CURRAGH RESOURCES - FARO MINE

REPORT  
ON  
1987 SITE VISIT

Prepared For:  
NORTHERN AFFAIRS PROGRAM  
Whitehorse, Y.T.

July, 1987  
G052-4

Photos 1 and 2: Cracks encountered on the crest of the dam are fresh, up to 10 cm wide and mostly sub-parallel with the upstream face.

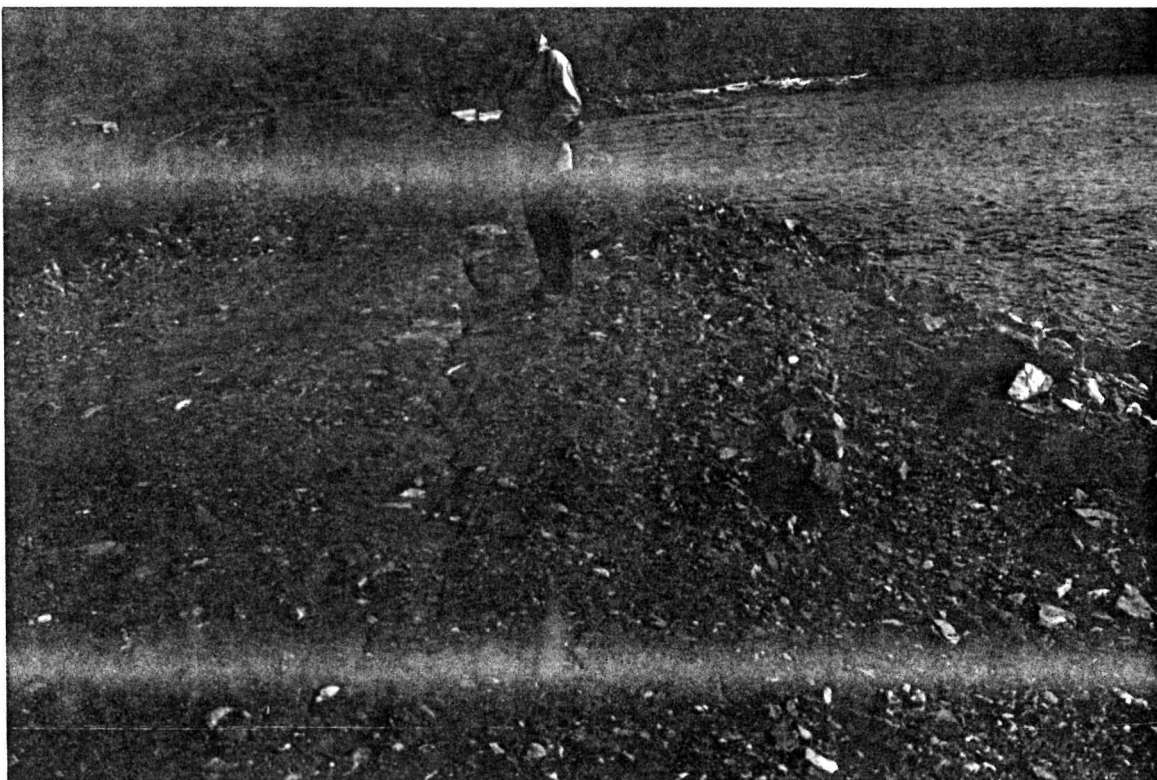
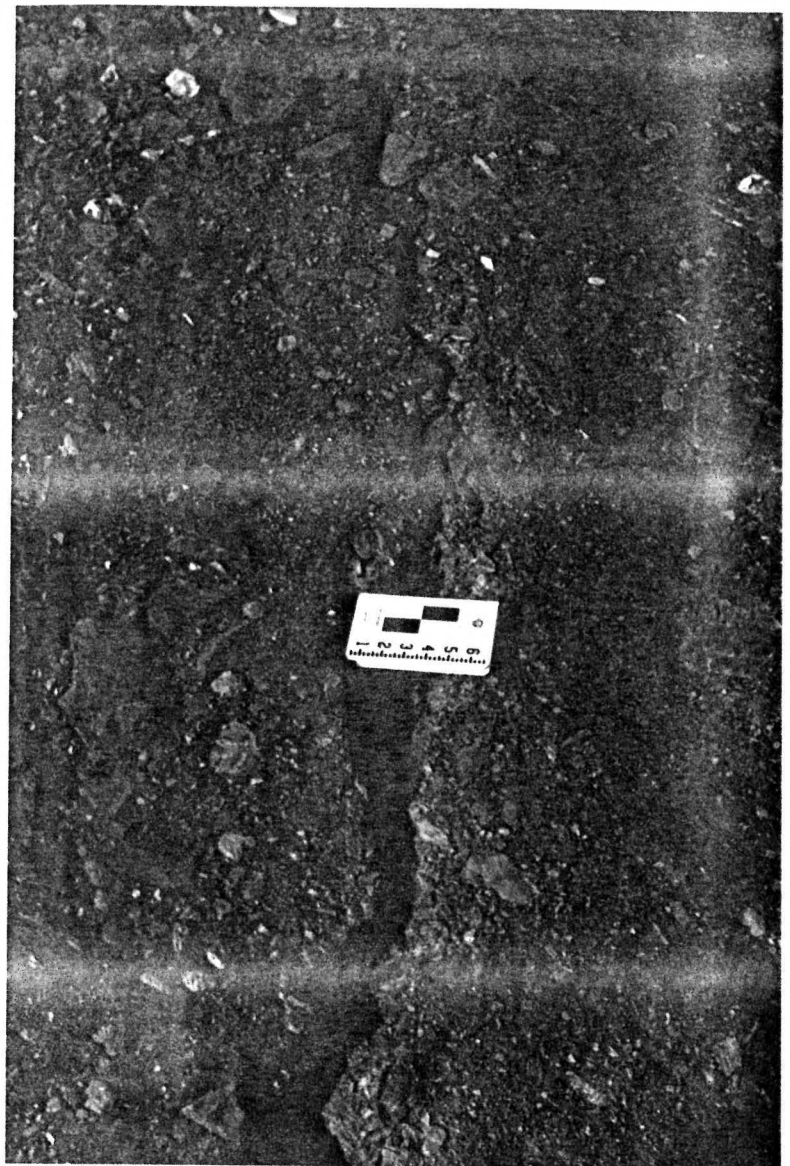
An almost continuous crack (and locally several subparallel arcuate cracks) traverse the top of the dam (Photo Nos. 1 and 2). In most instances, the crack is located approximately 1.0 to 2.0 m from the upstream dam face. In the middle of the dam (BH 85-4), where the crest is about 5 m wide, the crack reaches a point approximately 4 m away from the upstream edge (Photo 3).

The existence of extensive cracks in the crest of the dam indicates an unstable upstream slope. The extent of the instability is believed to be serious, especially with respect to known high pore pressure conditions in the dam and its foundation. Therefore, it is recommended that you consider the following actions:

- ° Request that the owner undertakes an evaluation of the stability of the dam.
- ° When evaluating the stability of the dam and its segments, a realistic but most adverse combination of site and reservoir conditions should be considered.
- ° Request that the owner establishes a schedule of inspections and monitoring (including seepage pressures).
- ° Depending upon the results of the review, establish operation guidelines for the reservoir and, if necessary, request modifications of the structure to ensure a satisfactory Factor of Safety against foundation or dam failure.
- ° Institute a system of formal annual inspections and reporting with the objective to assess the dam and reservoir conditions from year to year.

Photo 4: Standpipe BH 85-2  
measured 1.8 m pressure  
head above the toe berm.  
Note the seepage surfacing  
at the toe.

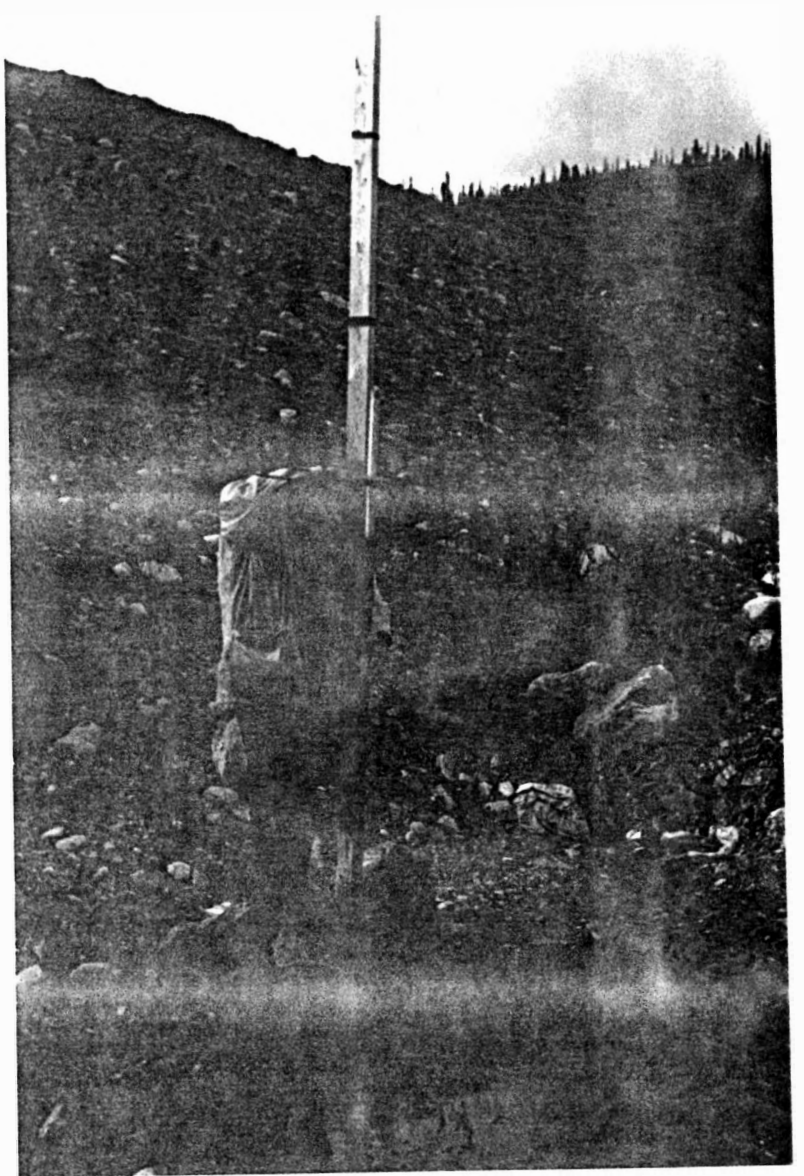
Extensive seepages exist along the toe of the downstream face of the dam. In the middle section of the dam and towards its south abutment, wet spots and growth of willows up to a line about 2 m above the ground surface indicate seepage discharges at these locations. Standpipe

BH 85-2 measured 1.8 m pressure head above the surface of the toe support berm (Photo 4).

Photo 5: Heavy seepage along  
the toe berm.

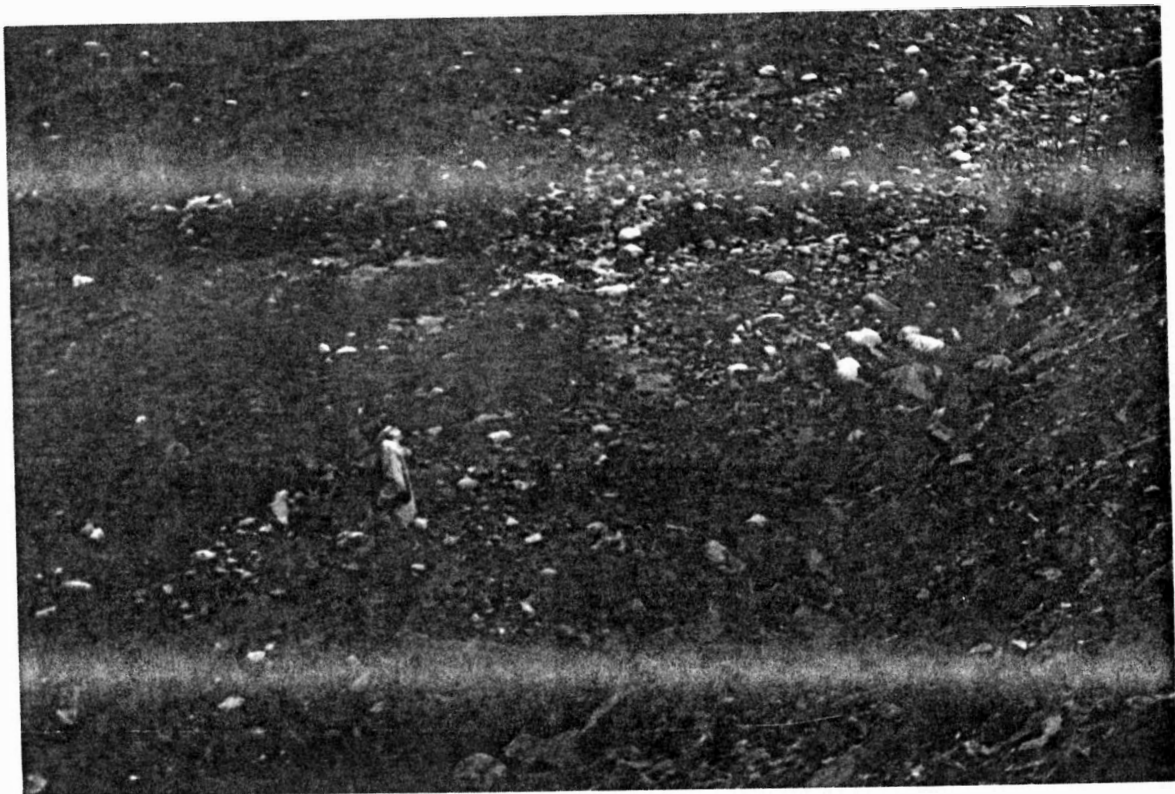
The ground immediately downstream from the toe berm is saturated and heavy seepage discharges exist throughout this area (Photo 5). The soil is in a loose (or in the case of localized cohesive materials in a soft) state of consistency, confirming existence of high pore pressures.

Photo 7: Seepage discharges into borrow pit "I." The borrow pit slopes are unstable. There are fissures and cracks on the face of the dyke and along its toe.

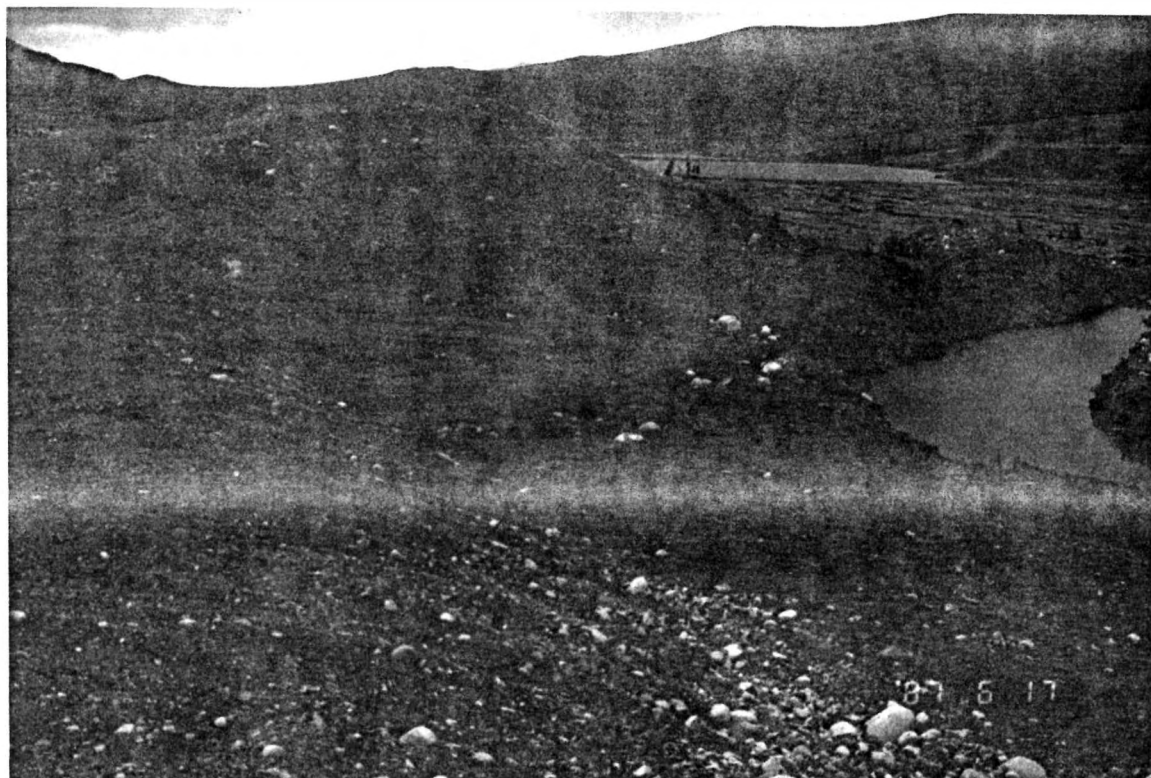
- ° Seepage discharges and ponding of water along or below the toe of the canal dyke, such as documented by Photo Nos. 7 and 9. This could adversely affect the stability of the dyke. Presently, the most critical situation is in the area adjacent to borrow pit "I" where a fresh mudflow (Photo 8) is retrogressing towards the dyke. Cracks, quite fresh and up to 10 mm wide, cut across the dyke toe area at this location. The volume of seepage is considerably larger than that experienced during the early stages of the canal operation.

- improvement of drainage and stability conditions in the borrow pit "I" area,
- regular (at least monthly during the warm season) visual monitoring of cracks and stability aspects of this area,
- development of stabilization measures should a retrogressive failure be indicated, and
- draining of the water ponded along the toe of the canal dyke at other locations as well.

Photo 12: View of the decant, emergency spillway and adjacent embankment of the Intermediate Dam. The integrity of this structure, at the present time, is governed by the stability of both spillways.

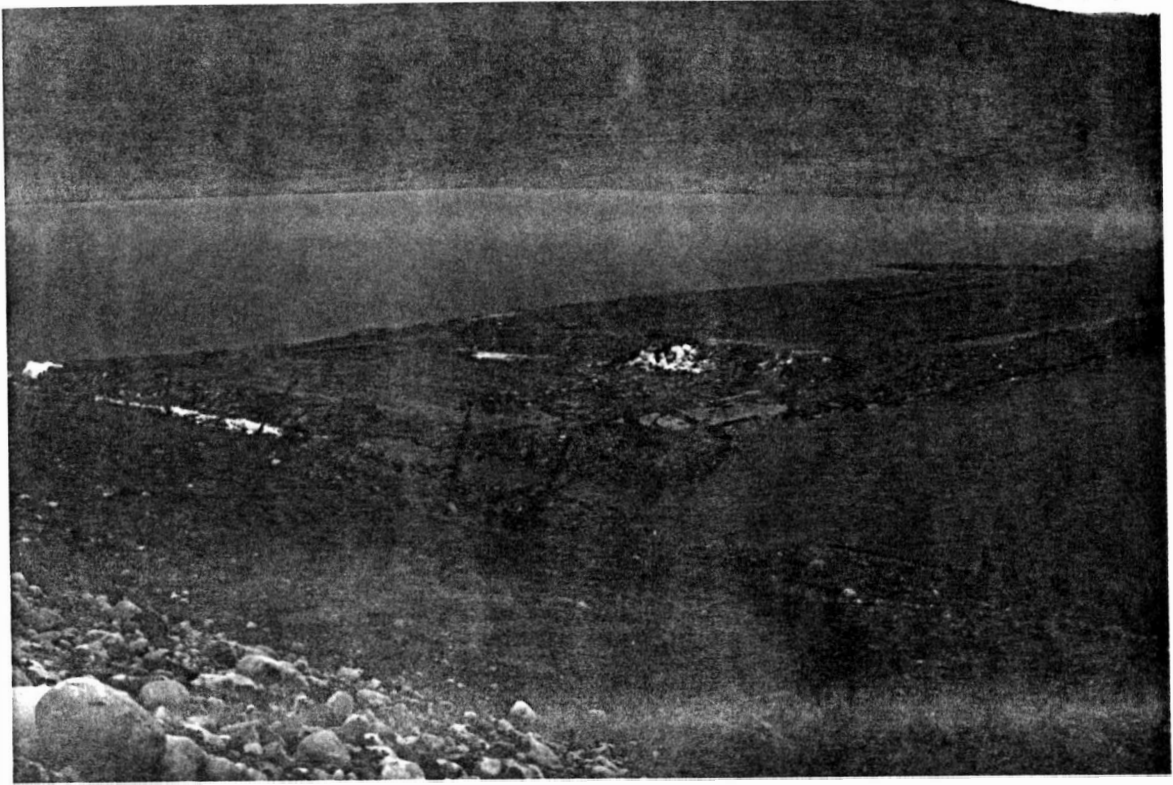
Water level in the tailings pond was only slightly below the sill elevation of the emergency spillway, controlled by the overflow through the decant channel (Photo 12).

Clean-up of the emergency spillway is required. It would be prudent to grade the sill by selective placement of heavy rip-rap.

In concluding, the integrity of the Intermediate Dam is currently governed by the stability of both spillways. Consequently, these structures should be carefully maintained and monitored.

Photo 13: Crest of the Cross Valley dam looking south. An arcuate crack in front; further to the south the crack parallels the upstream edge of the crest.

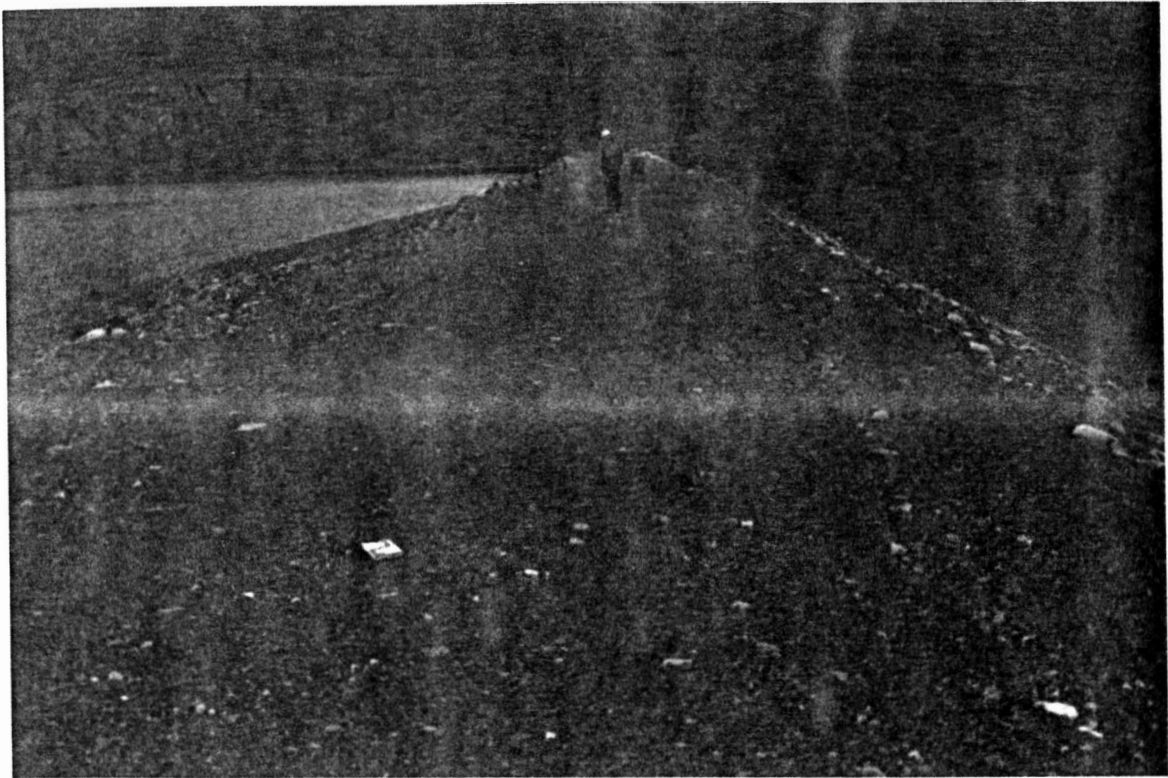
Our examination of the dam crest revealed existence of cracks which are locally arcuate and elsewhere subparallel with the upstream edge (Photo Nos. 13 and 14). The width of cracks range from 5 mm to 75 mm. They probably occurred relatively recently since they were not observed by Mr. H.G. Gilchrist during his October, 1986 site inspection. However, no major deformations have been identified on either slope of the dam.

Since the cracks are, in most instances, closer to the upstream edge (except the centre of the dam and at the south abutment where they are approximately in the middle of the crest) settlement or an instability of the upstream face of the dam is suspected. This deformation may be influenced by the reported increase in the piezometric levels beneath the upstream blanket (between October, 1984 and October, 1986 in the range of 1.4 to 2.8 m) as well as beneath the core (between 0.88 and 2.26 m). A detailed survey of the cracks and review and analysis of soil and pore pressure data should be undertaken in order to determine the probable causes and to evaluate the possible consequences of these deformations.

- ° detailed surveys of cracks and recent pore pressures,
- ° evaluation of the dam stability,
- ° regular and frequent (for example, monthly) monitoring of piezometers and seepage flows,
- ° frequent visual inspections of cracks (relative to installed reference points) and other surface features.

Photo 15: Seepage discharges from the south abutment and along the toe of the dam.

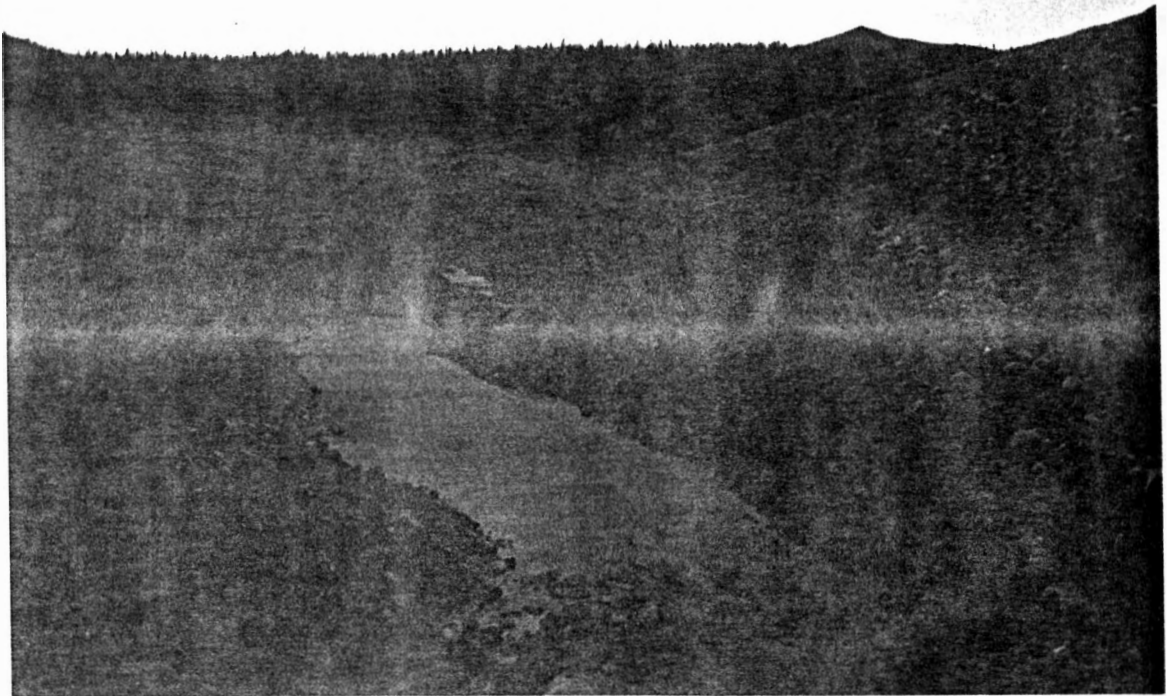
Heavy seepages occur at both dam abutments and along the dam toe (Photo Nos. 15 and 16). The total seepage flow (measured at weir W3) reached a peak volume of 128 l/sec (1685 igpm) in July and August, 1986. The volume of seepage discharged from both abutments is quite similar, approximately 18 l/sec (240 igpm) at each one. Consideration should be given to the fact that additional flow occurs below the ground surface and bypasses the measuring stations. It is our opinion that the

While the volume of apparent seepage is high, reduction of percolation capability of the surface material may result in increased pore pressure and be detrimental to the dam stability.

Photo 22: Unstable dump at  
the relocated Faro Creek.

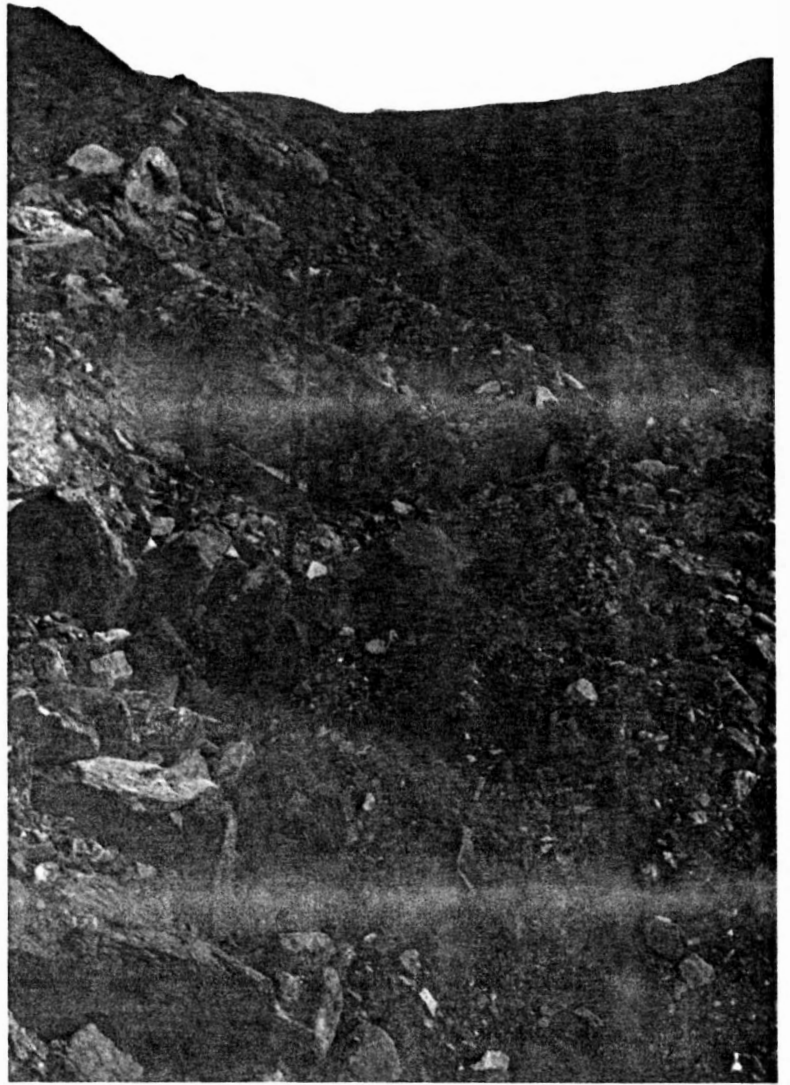
The overall stability of these dumps appears to be good. Our inspection revealed localized instabilities such as those documented on Photo Nos. 21 and 22.

While these instabilities are apparently infrequent, they document relatively low Factor of Safety (at least for the dump surfaces) and are indicative of possible long-term stability problems which could locally develop. In our view it would be prudent to:

- ° acquire a map showing the current configuration of the dump, and
- ° classify the dumps according to their stability.

Photo 24: One of minor drainage courses traversing the proposed Grum waste pile area.

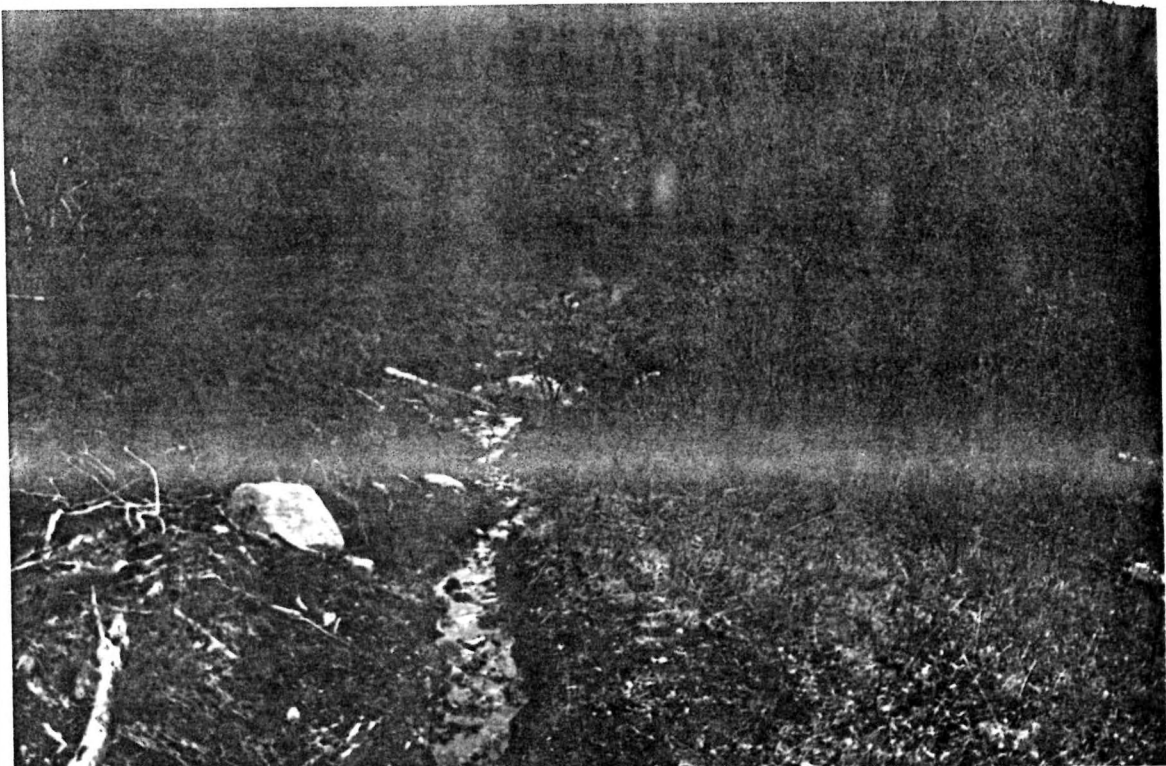
- ° While the overall terrain configuration of the area designated for the disposition of waste from the Grum pit appears to be suitable for the dump (Photo 23), there are localized zones comprising soft overburden and minor drainage courses (Photo 24). A detailed evaluation of the foundation conditions with the emphasis on the final dump configuration is required.
